# ***Nords Wharf Concept Plan***

*Part 3A Modification  
Assessment  
(MP 10\_0088 MOD 1)*

January 2020

**Figure 5** | Proposed subdivision layout

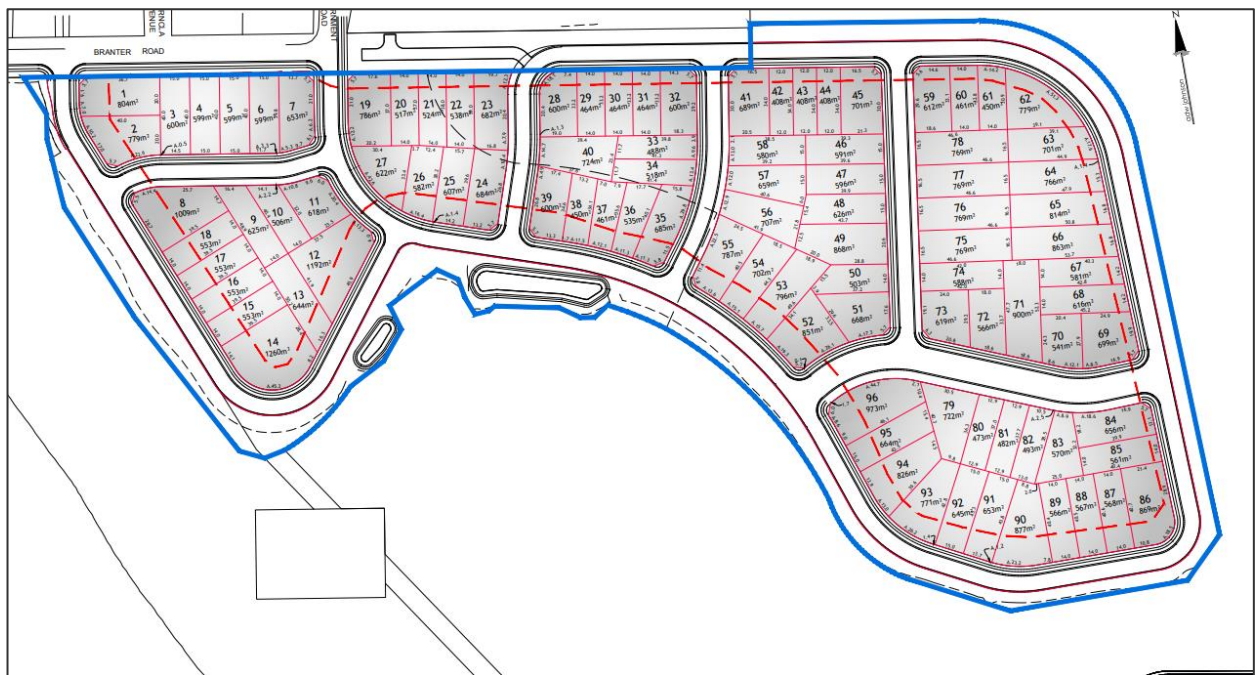
- the Crown road reserve (proposed lots 301-306) has been approved to become a public road and not transferred to private ownership
- inadequate details about proposed cut and fill have been provided

- the impacts of the proposed intersection changes on the local road network have not been sufficiently addressed
- the approved layout includes large lots adjacent to the Branter Road landscape buffer and the proposed lot layout includes smaller lots which may have a negative impact on achieving the buffer

- the proposed modifications are inconsistent with the Urban Design Guidelines approved for the site.

Issue	Findings	Recommended Condition
<i>Subdivision layout</i>	<ul style="list-style-type: none"> <li>The proposal seeks to modify the subdivision layout to increase the number of lots from 90 to 96.</li> <li>The Department considers the proposed subdivision layout is acceptable as: <ul style="list-style-type: none"> <li>the majority of lots meet the minimum lot size of 450m<sup>2</sup> and lot width of 14m in accordance with the Lake Macquarie LEP 2014</li> <li>the battle-axe blocks, proposed as part of the original modification request, have been removed</li> <li>it would contribute to the provision of additional housing in the Hunter region in accordance with the regional plan.</li> </ul> </li> <li>The Department also notes that the proposal relates to a concept plan, therefore the layout is indicative only, and the design will be finalised as part of future DAs assessed by Council.</li> </ul>	Modified Condition 1.4 stating that the approved subdivision plan is indicative only.

**Figure 8** | Proposed intersection design

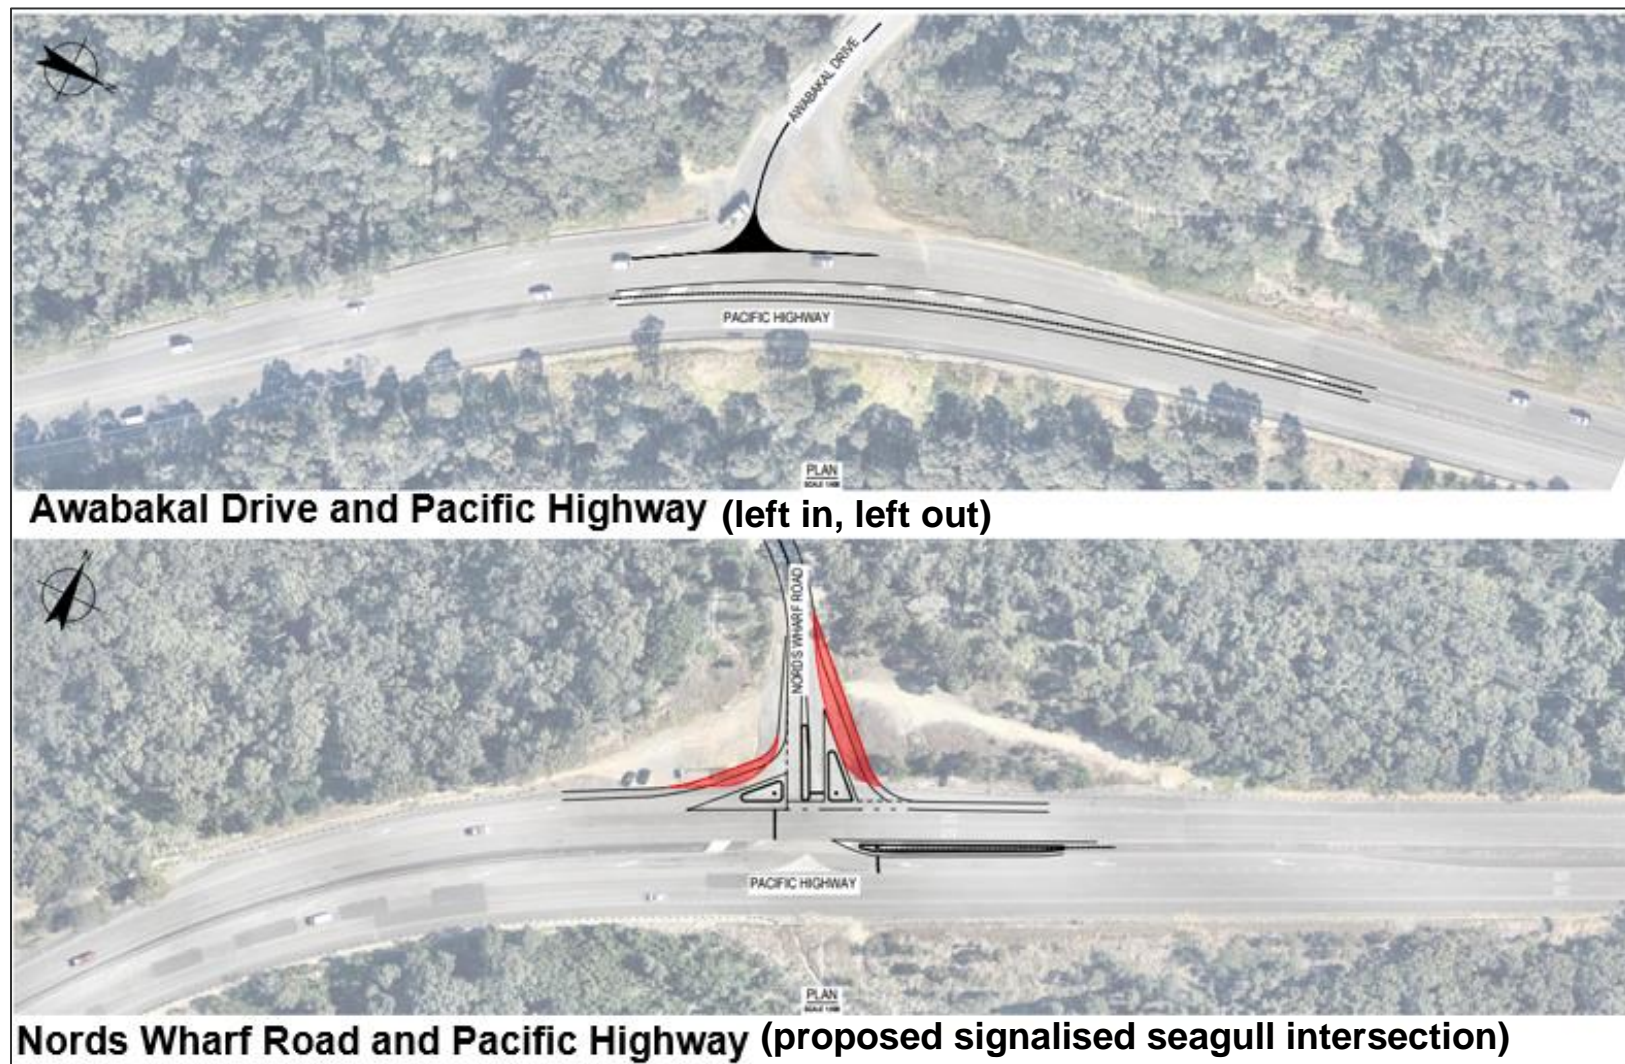
- 6.2.1 The proposal seeks to change the intersection of the Pacific Highway and Awabakal Drive to left-in, left-out only, and modify the intersection of Nords Wharf Road and the Pacific Highway to a signalised seagull intersection (as summarised in **Table 6** and outlined in **Figure 8**).

- 6.2.5 RMS advised that either option (approved or proposed) could provide an acceptable safety and efficiency outcome. It recommended that the Department may determine the appropriate intersection treatment following consultation with the local community, to allow full consideration of the environmental impacts of the proposed changes to intersection upgrades.

- 6.2.6 Based on the advice of RMS, the Department acknowledges that either option could provide a safe and efficient outcome in relation to the ingress and egress from the Pacific Highway. However, following a review of all environmental impacts and consultation with the community, the Department does not support the proposed changes to intersections.

- 6.2.7 The Department notes that the proposal would alter the local road traffic flows in the area, as residents wishing to travel south along the Pacific Highway would need to travel north along a local road (Government Road) to use the Nords Wharf Road intersection (**Figure 7**). This would increase the amount of traffic on local roads and inconvenience residents (particularly those in the south of Nords Wharf).

- 6.2.8 The Proponent submitted a Traffic Impact Assessment (TIA) as part of the modification request, stating that an additional travel time of 2 minutes for 20% of residents would be incurred as a result of the proposed changes. However, RMS disagrees and notes it is likely that more than 20% of residents would be affected, as the distribution diagrams do not consider that people are likely to use the closest intersection.
